# PARTS & SERVICE NEWS

REF NO.	AT03084
DATE	May. 19, 2003

**SUBJECT:** TRANSMISSION INCHING CLUTCH IMPROVEMENT PARTS (SPRING) ON GD825A-2

**PURPOSE:** To introduce a new valve part (spring) for improving durability of inching clutches by lowering hydraulic oil pressure.

#### 4. Details of Modification

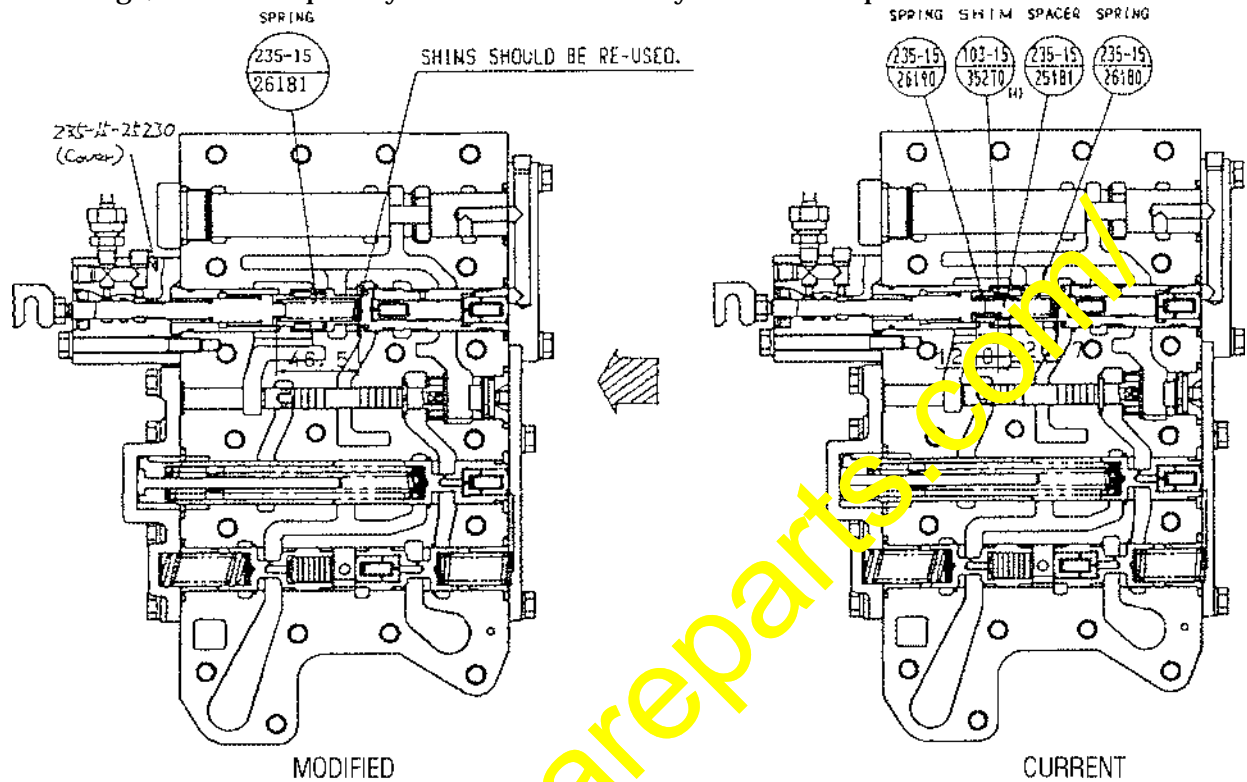
The heat building up at the time of sliding the clutch has been reduced with the inching pedal operation range remaining and by decreasing the pressure adjustment range, and consequently the clutch durability has been improved.

The inching oil pressure (the upper limit value in the pressure adjustment range for inching) can be lowered as shown above by replacing the spring inside the inching valve (installed on the top of the transmission). Therefore, even if the operator inches it for a long time by mistake, the clutch heat building up will decrease and the durability of the inching clutch is improved.

##### (2) List of Parts for Modification

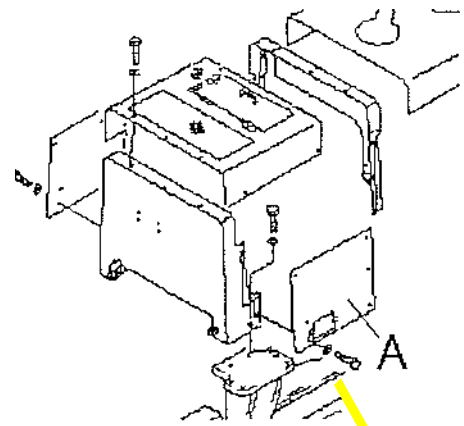
Parts prepared			
Part No.	Description	Quantity per unit	Remarks
235-15-26181	Spring	1	Parts to be mounted, Free height 64, Total number of windings 21.6

Unnecessary parts after replacement			
Part No.	Description	Quantity per unit	Remarks
235-15-26190	Spring	1	To be removed, Free height 17.6
235-15-26180	Spring	1	To be removed, Free height 39.4
235-15-25181	Spacer	1	To be removed, Overall length 23.6
103-15-35270	Shim	About 4	All shims are removed.

(5) Disassembly of Valve and Replacement of Spring

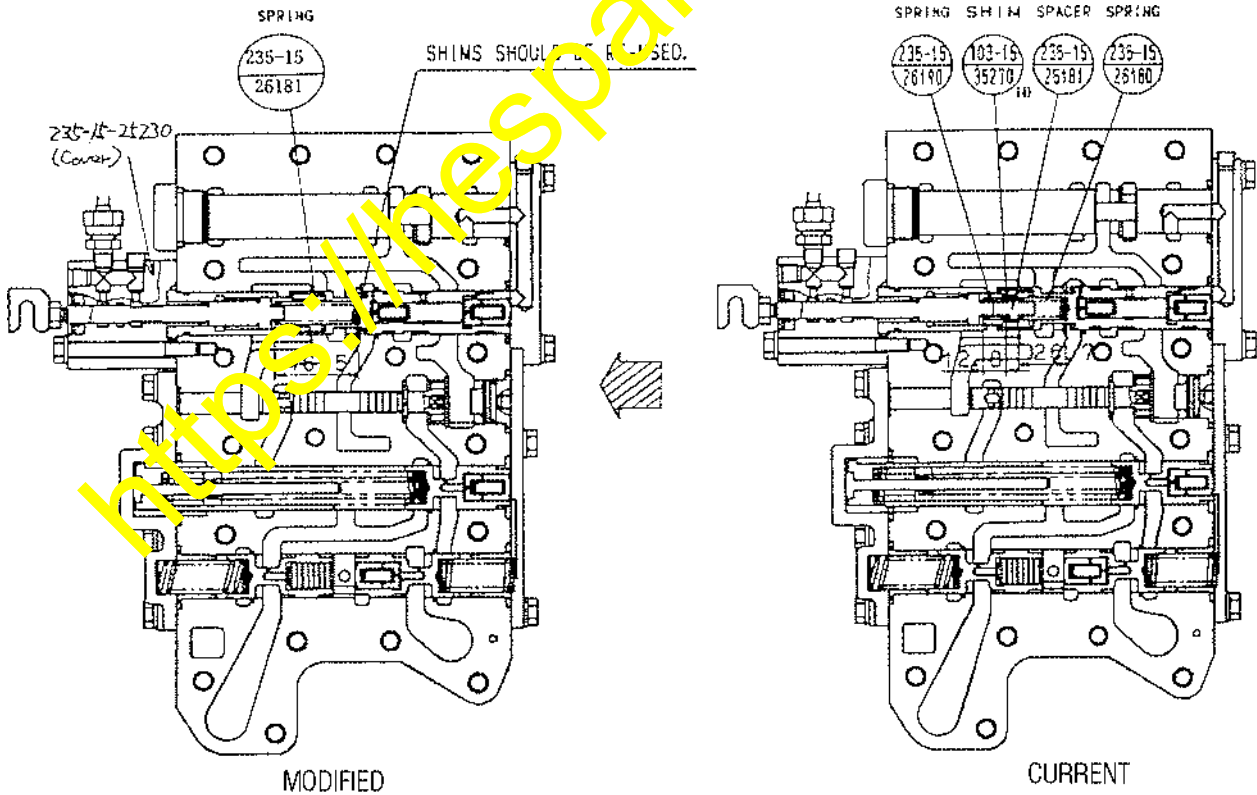
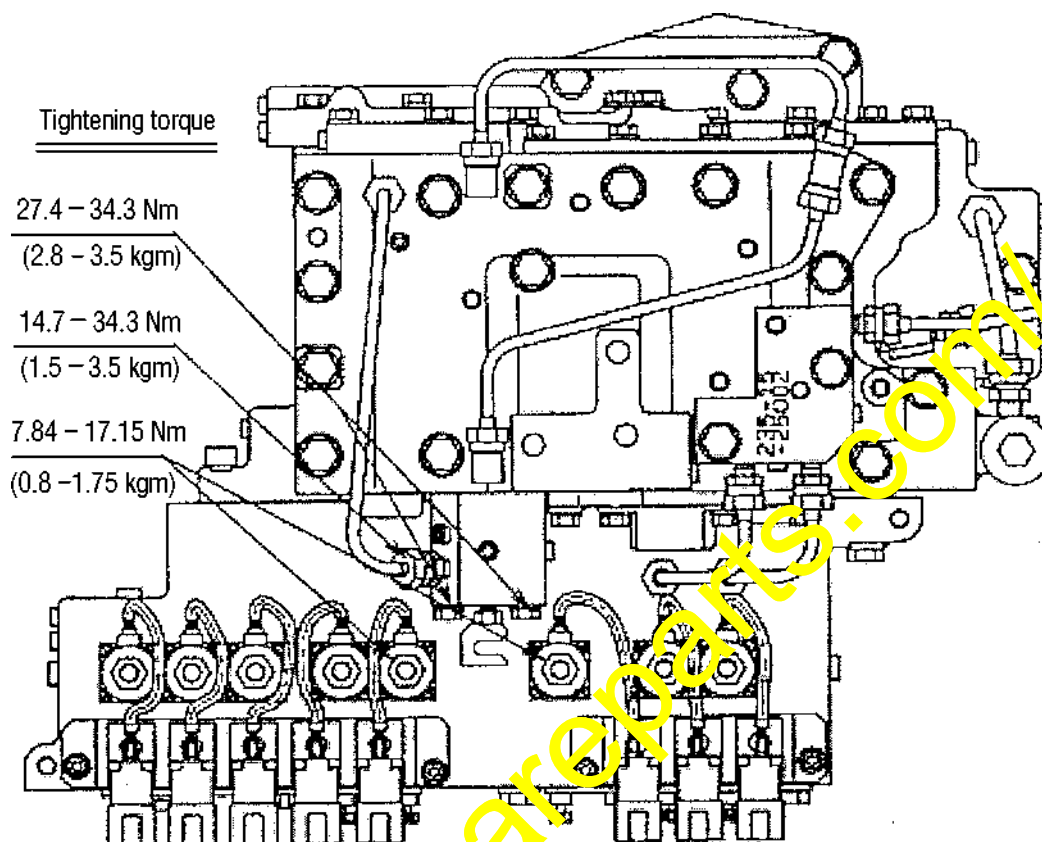
The inside is as shown in the figure below. Assemble the spring and other parts correctly.
